Chesapeake modifications to Regional Standards Third Edition

DESIGN AND CONSTRUCTION STANDARDS			
		PRECAST CONCRETE SHALLOW MANHOLE			
DR. BY:	DATE:	SS_02	03		
08/15/03	REV. FOR INTERNET 2003			CHK. BY:	DATE:
DATE	REVISIONS			APP. BY:	DATE:

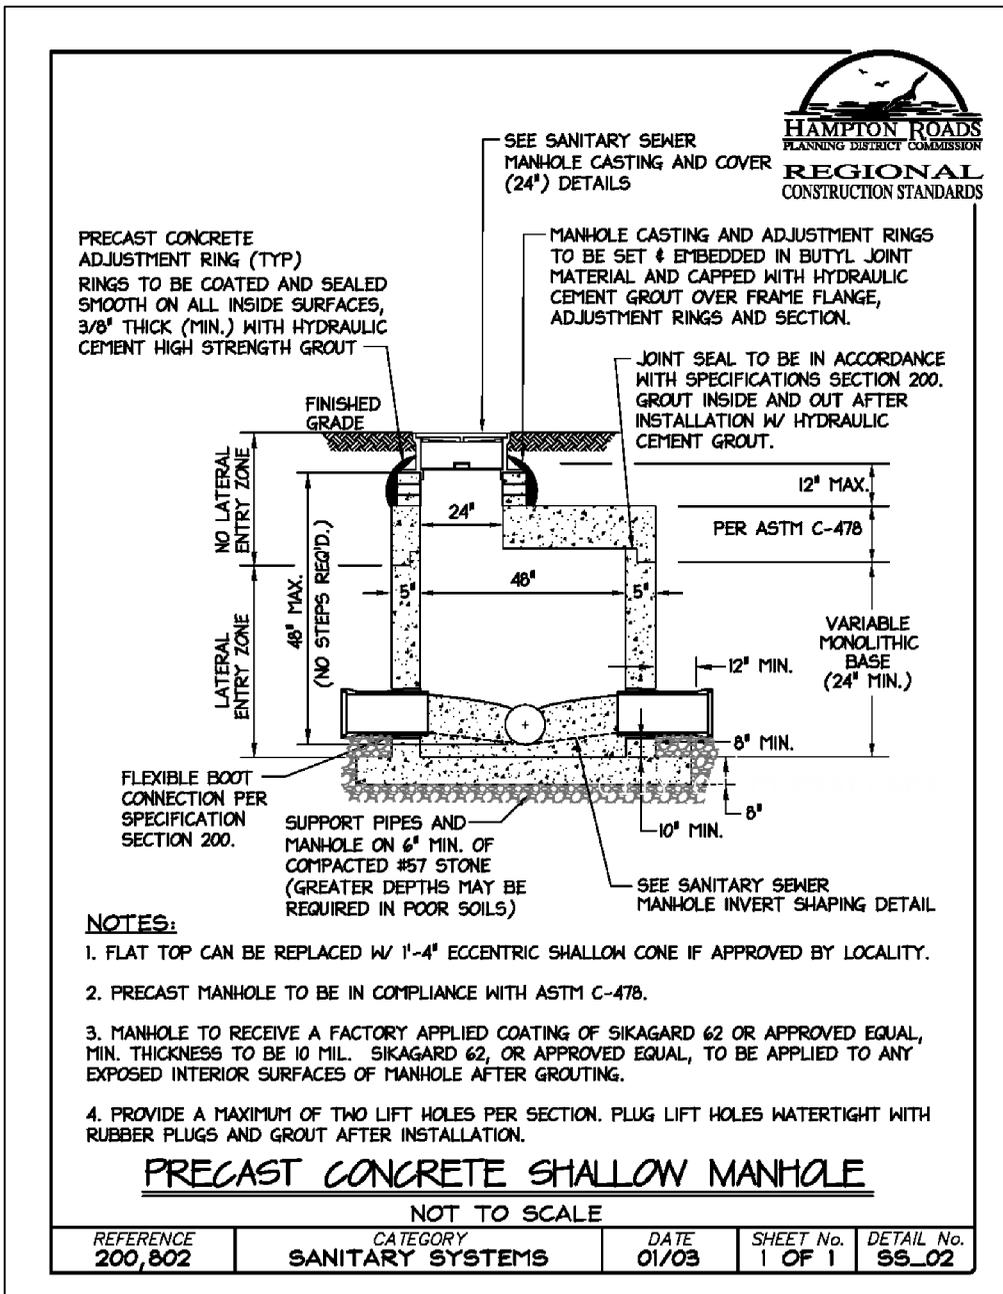
1. A minimum of one 4 inch adjustment ring to be added at time of construction to allow for future adjustments.
2. After grouting lift holes they shall be field coated as noted in note 3.
3. Casting to be placed over the outlet pipe.
4. Special designs required for manholes less than 30 inches from rim to invert.
5. Watertight insert to be provided with casting in accordance with Volumes I & III of PFM.
